ZION NUCLEAR POWER STATION, UNIT 2

AMENDMENT TO FACILITY OPERATING LICENSE

Amendment No. 167
License No. DPR-48

**PERMANENTLY DEFUELED
TECHNICAL SPECIFICATIONS**

Figure 3.1.3-1
 Fuel Assembly Burnup Limits in Region 2

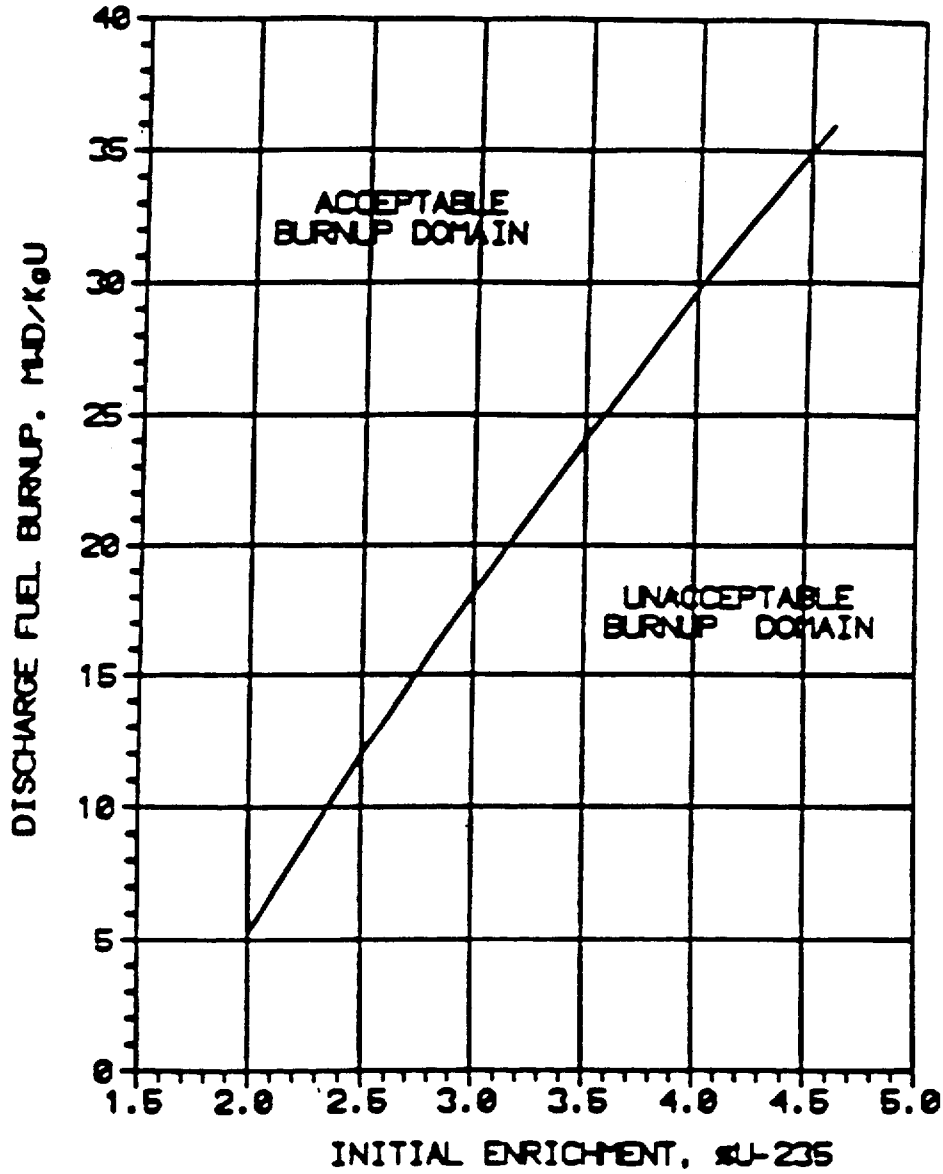
LCO 3.1.3 The combination of initial enrichment and discharge fuel burnup of each spent fuel assembly stored in Region 2 shall be within the Acceptable Burnup Domain of Figure 3.1.3-1.

- f. Irradiated fuel assemblies with a discharge burnup in the "acceptable burnup domain" of Figure 3.1.3-1 allowed unrestricted storage in either Region 1 or Region 2 of the spent fuel storage rack(s); and

- g. New or irradiated fuel assemblies with a discharge burnup in the "unacceptable burnup domain" of Figure 3.1.3-1 stored in Region 1 of the spent fuel storage racks.
